Re: Plan Check # 10174195 520 E. Dyer Rd., Santa Ana, CA

TENANT IMPROVEMENT PLAN CHECK COMMENTS

PLAN CHECK NO:	10174195	
PROJECT ADDRESS:	520 E Dyer Rd	
PLAN CHECK ENGINEER:	Kwak, Jason	TEL: 714 647-5866
		FAX: 714 647-5897
TYPE OF CONSTRUCTION:	V B, SPK	
OCCUPANCY CLASSIFICATION(S):	B, S-1	
PLAN CHECK DATES:		REMARKS/RECHECK ITEMS:
APPLICATION	1/19/2012	
INITIAL REVIEW	1/24/2012	
EXPIRATION	7/17/2012	
RECHECKS:	1.	PROJECT APPLICANT CONTACT PERSON: Rhoads Martin
	2.	
	3.	
VALUATION:	\$176,000.00	TEL: (714)241-1141
		FAX: (714)241-0847
		EMAIL: Rmartin@martincommercialgroup.com
FLOOD ZONE:	X-0602320278J

Issue Date	01/20/2012
Print Date	2/8/2012 4:46:09 AM
Sheet Number	A1

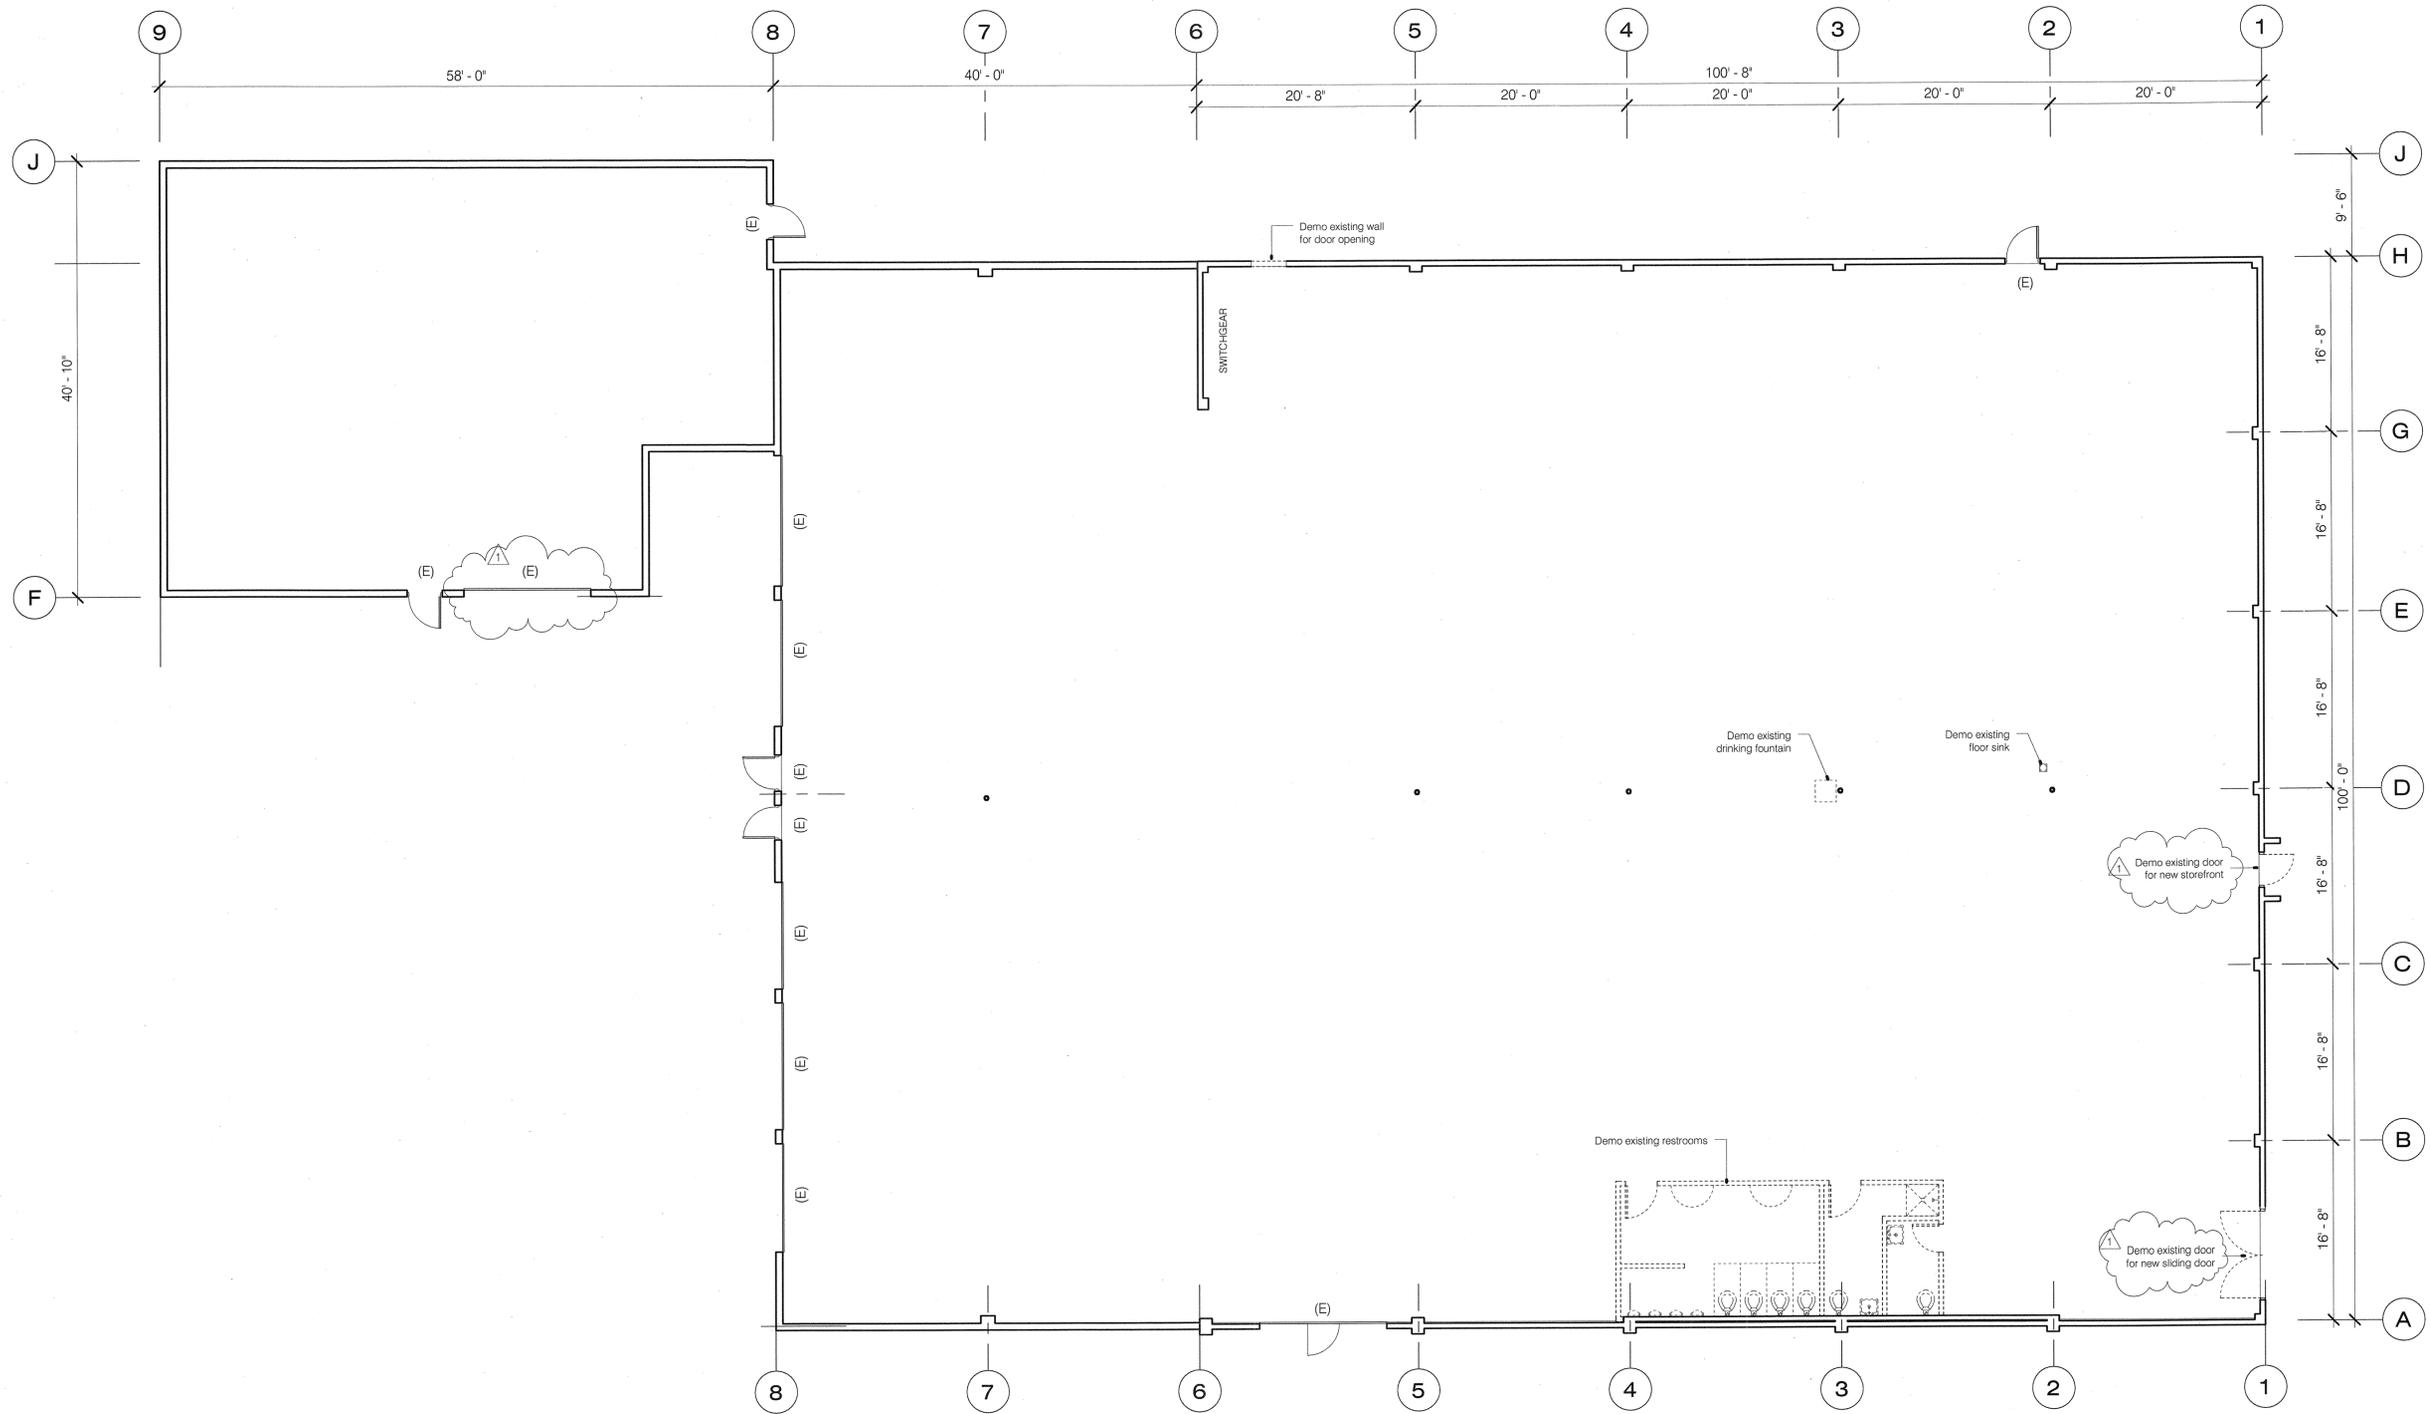
19. If a walk crosses or adjoins a vehicular way, and the walking surfaces are not separated by curbs, railings or other elements between the pedestrian areas and vehicular areas, the boundary between the areas shall be defined by a continuous detectable warning which is 36" wide, complying with the CBC Section 1133B.8.5. See enlarged parking detail, sheet A1

20. CBC Section 1129B.3, Item 3. Parking spaces must be located so that the disabled are not compelled to walk or wheel behind parked cars other than their own. See enlarged parking detail, sheet A1

Detectable Warning Product Approval. Only approved Division of the State Architect, Access Compliance (DSA/AC) approved detectable warning products and directional surfaces shall be installed in accordance with CBC Section 1133B.8.5. See enlarged parking detail, sheet A1

Issue Date	01/20/2012
Print Date	2/8/2012 4:46:10 AM
Sheet Number	A2

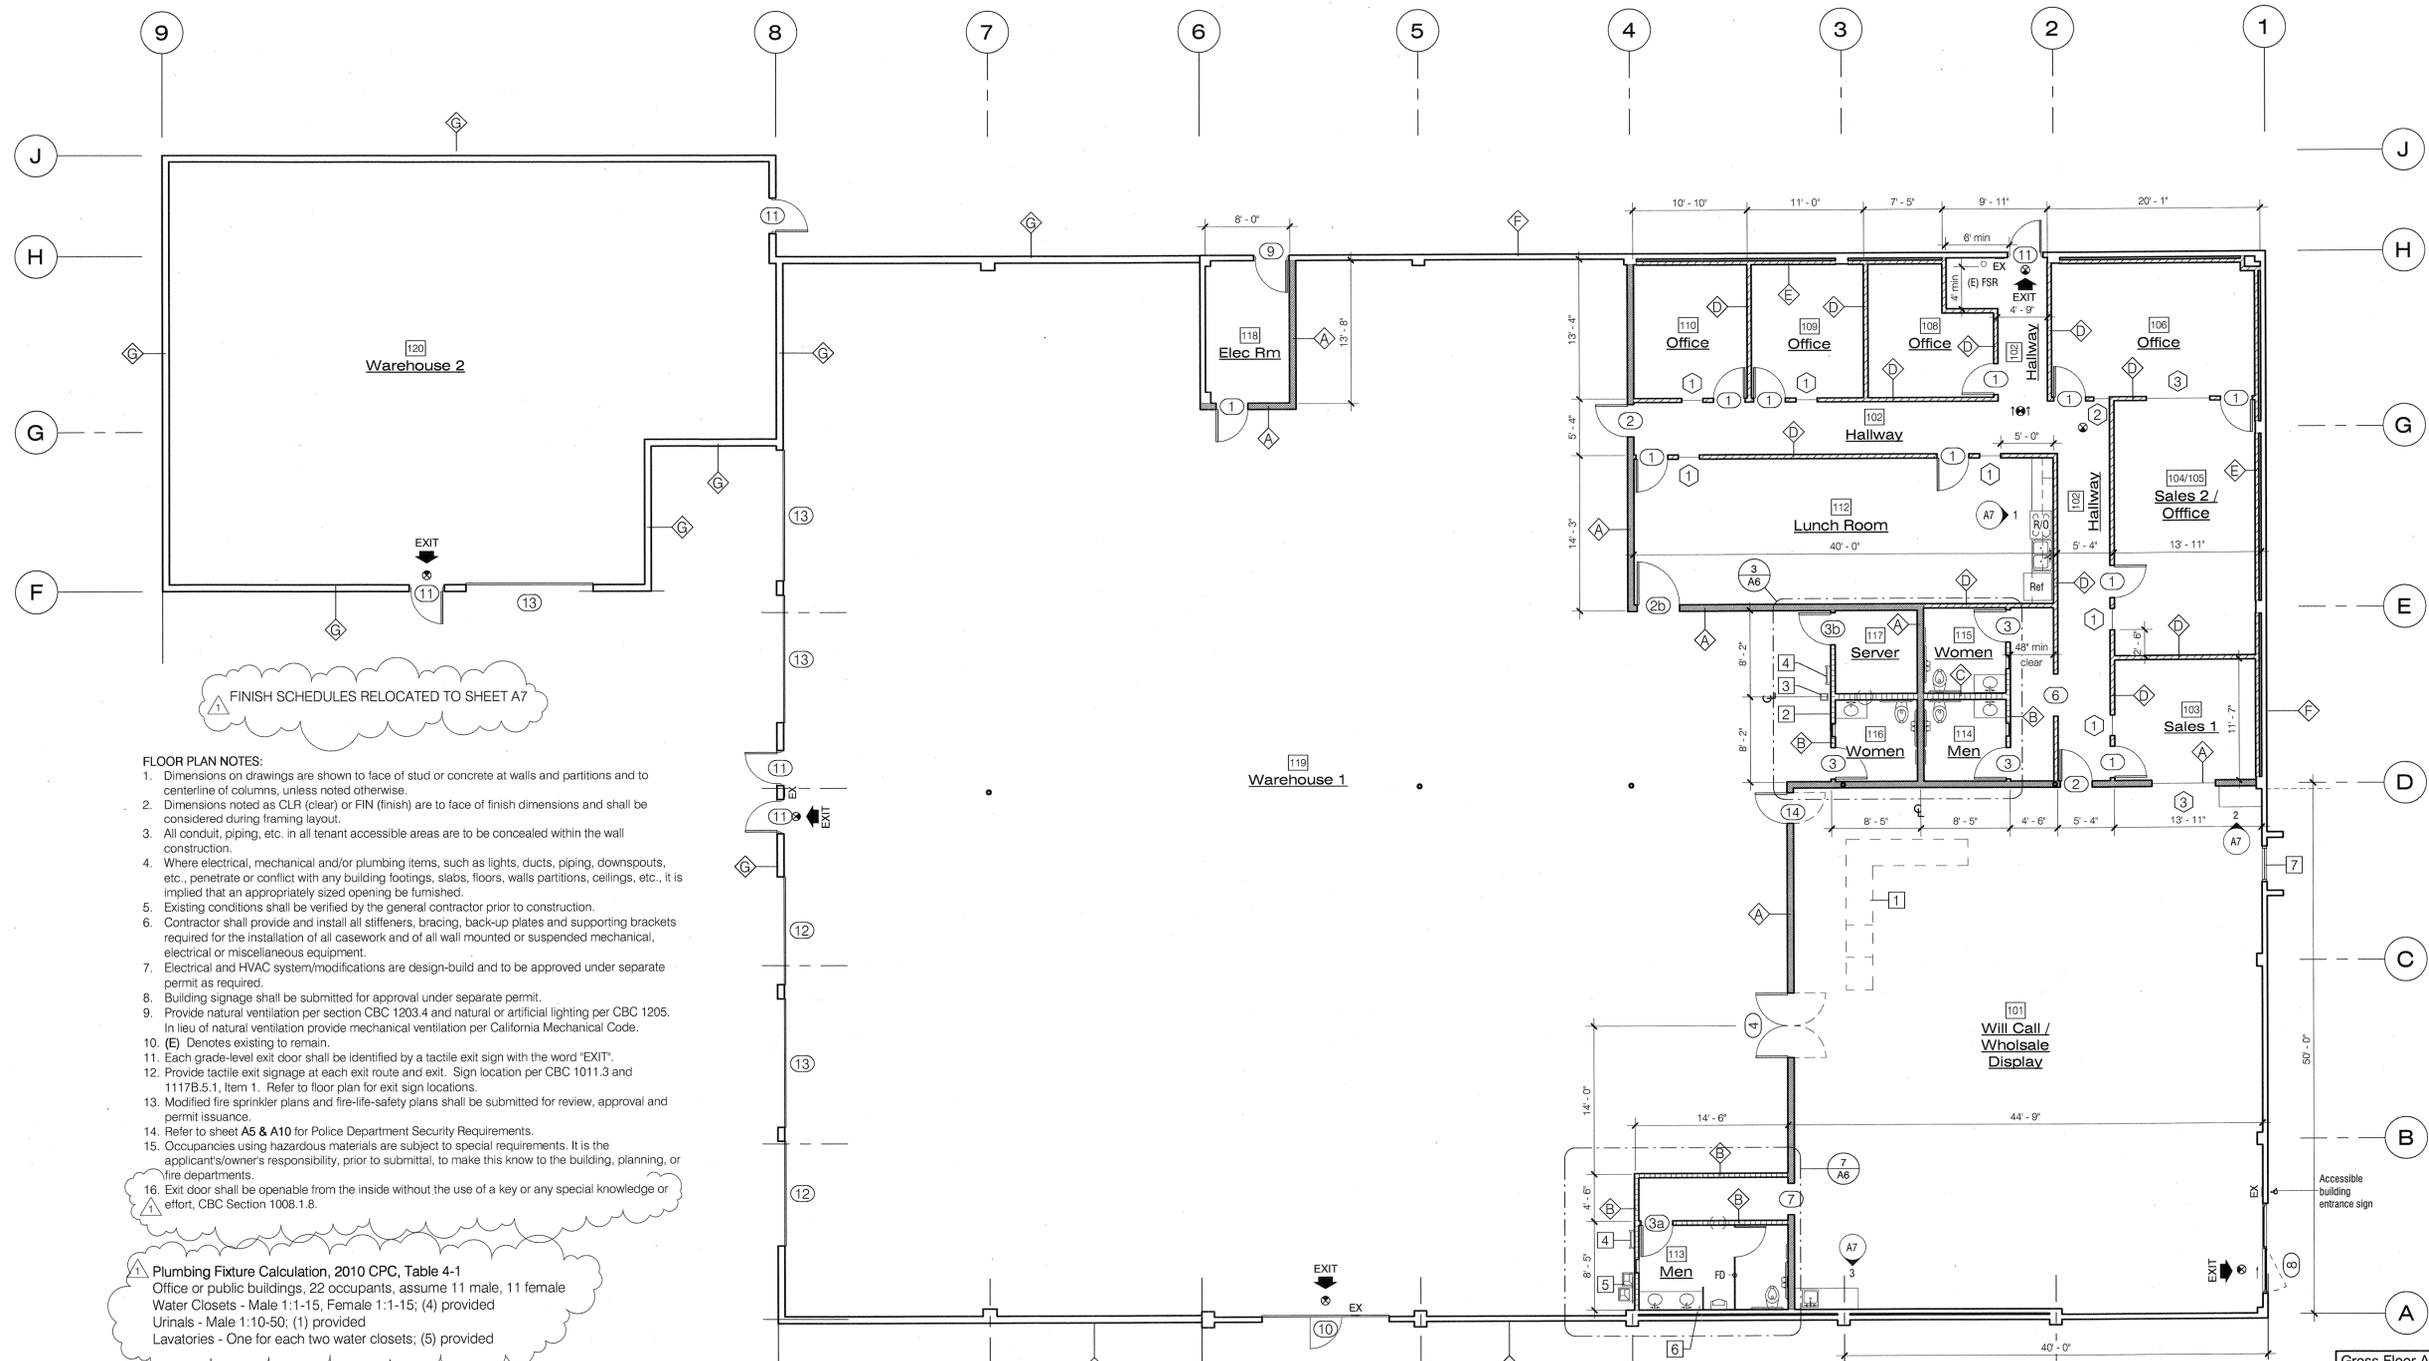
27. New door in door schedule and new structural for new opening in adjacent warehouse building is missing. There is only one new opening in the existing wall for access to Electrical Room. The other door was shown as new in error. See updated demo plan sheet A2 and floor plans A3

Johnstone Supply
 520 East Dyer Road, Santa Ana, California
 Issue Date 01/20/2012
 Print Date 2/8/2012 4:48:11 AM
 Sheet Number
A3

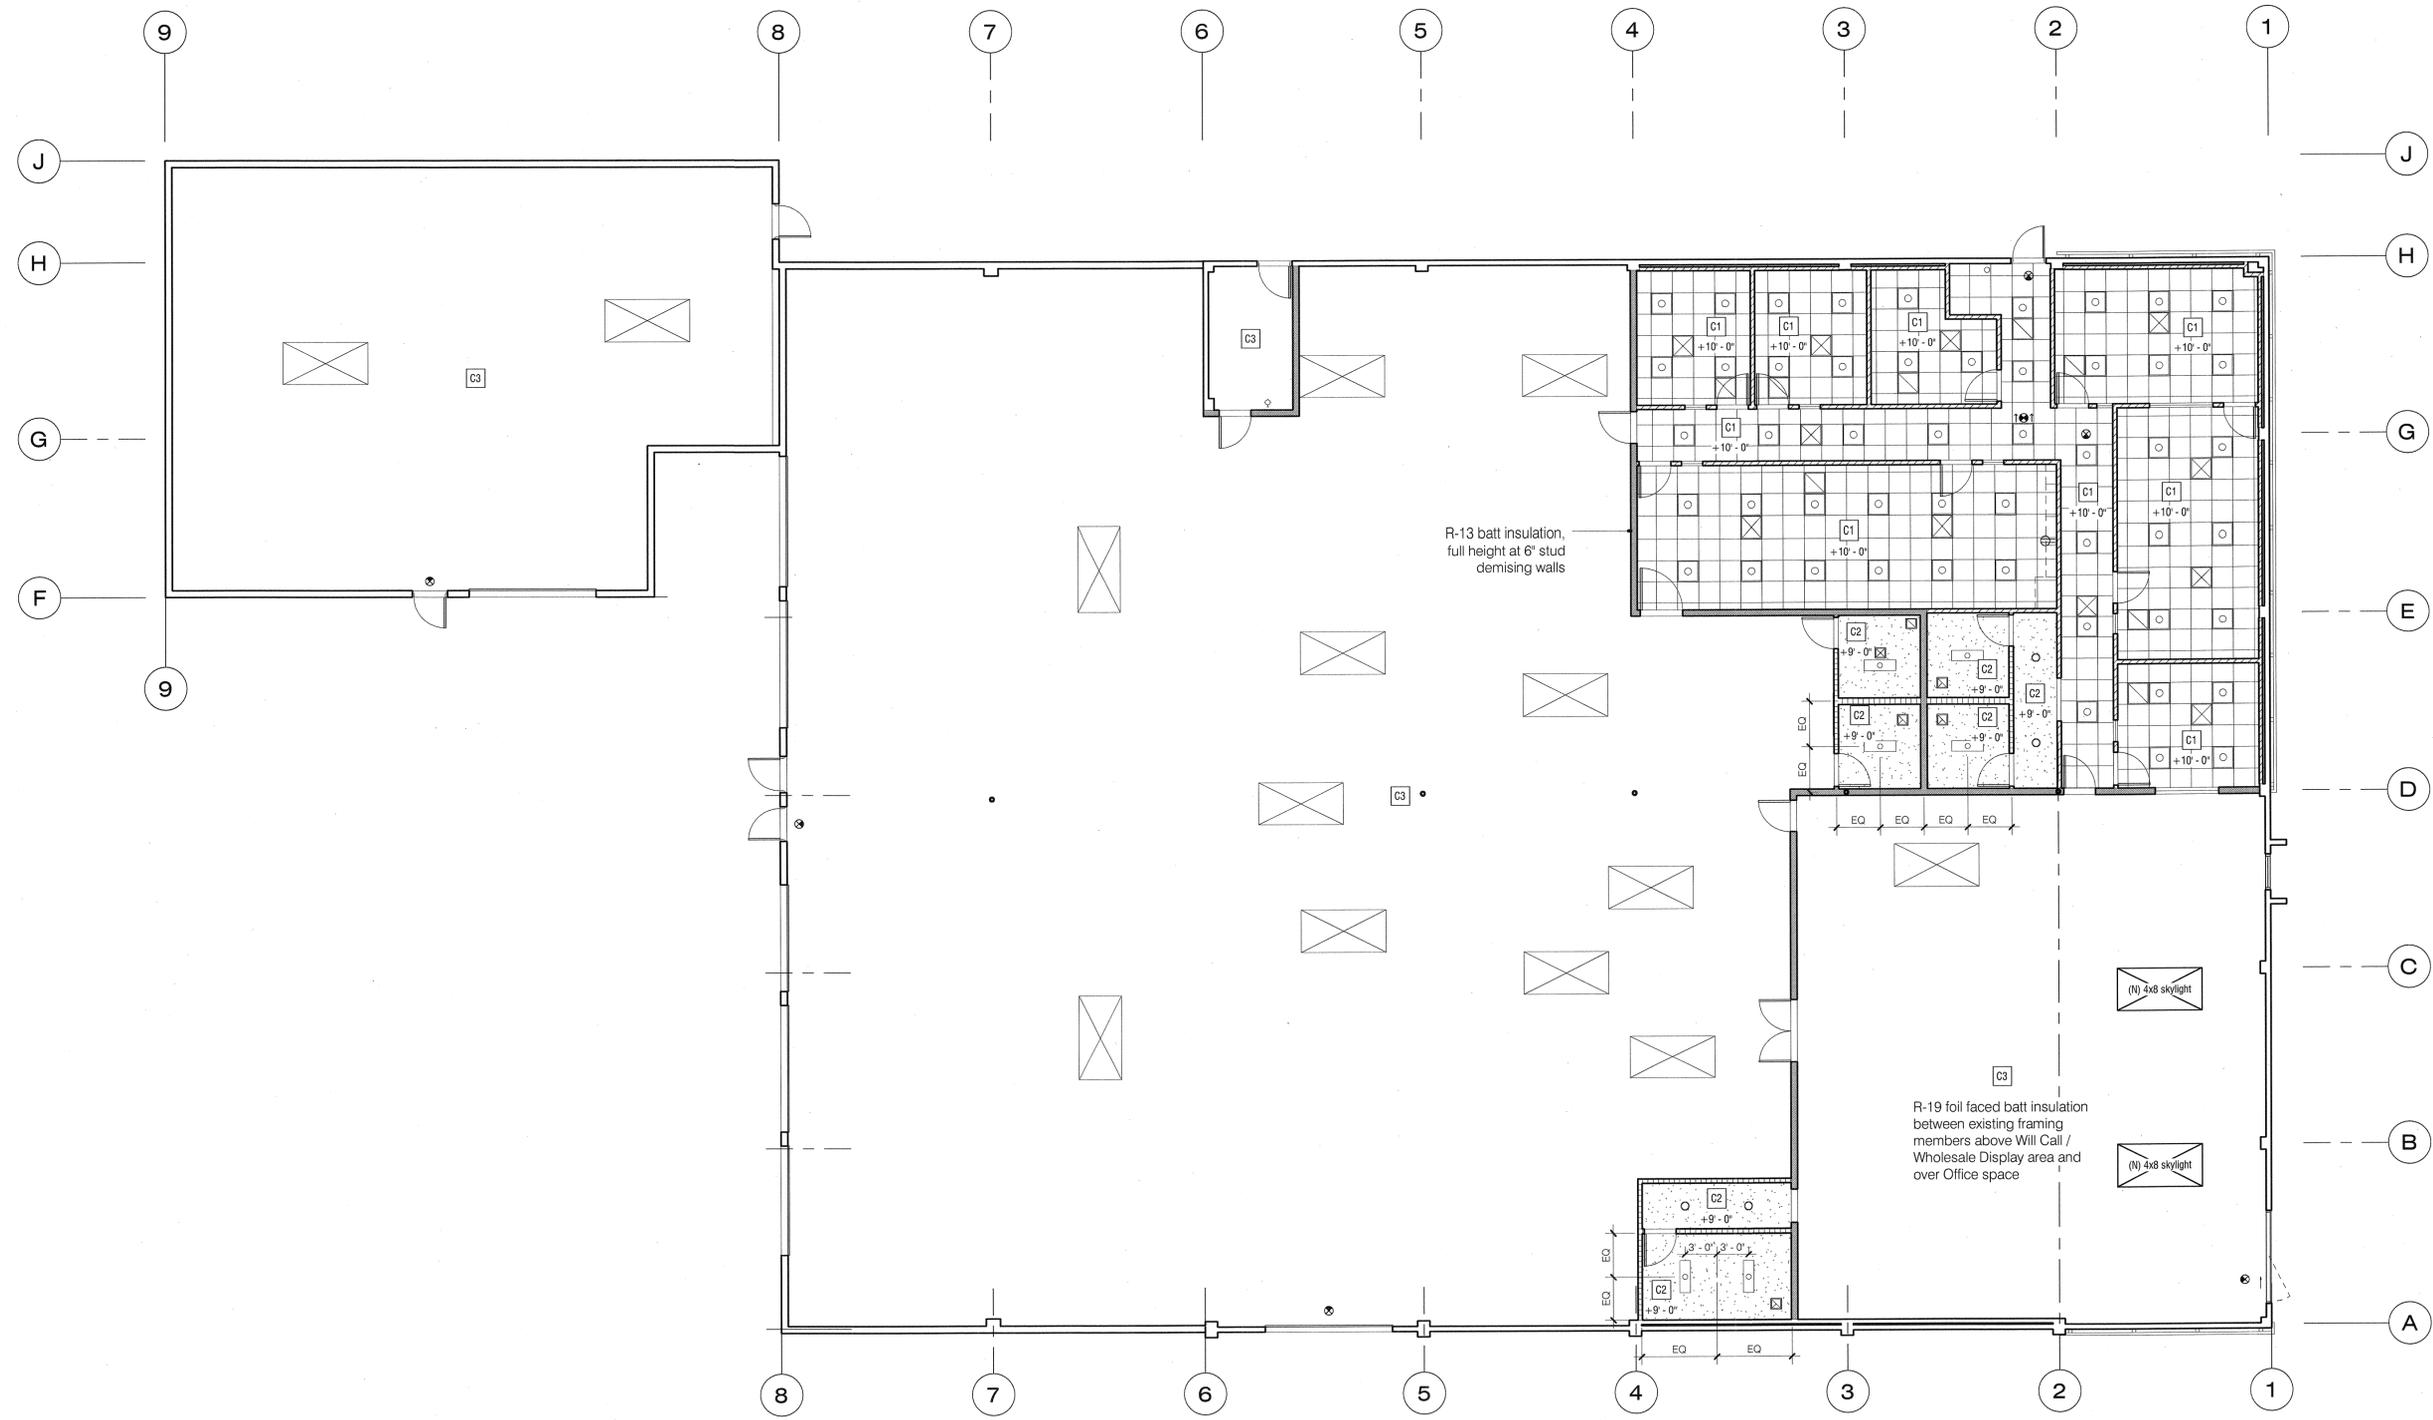
- Existing, new, or to be removed
 - A fire-resistive assemblyExisting exterior "shell" walls are tilt-up concrete or 8" masonry, Refer to Wall Type Schedule on sheet A3

11. Note on the floor plan the use and occupancy load of each room and/or area. Relate each use to a CBC Table item. Note occupant loads which are the greater number based on CBC Section 1004 and Table 1004.1.1 or the actual number of occupants. See Occupancy / Use Summary diagram and schedule on sheet A3 and letter of occupancy from tenant.

12. CBC Section 1008.1.8, Note on drawing: "Exit doors shall be openable from the inside without the use of a key or any special knowledge or effort." Note 16, sheet A3.

25. Verify roof parapet screening with Planning Division. Verified and approved
26. Provide a plumbing fixture calculation per the 2010 CPC. Verify the proposed number of restroom fixtures complies with the CPC. Refer to Plumbing fixture calculation on sheet A3
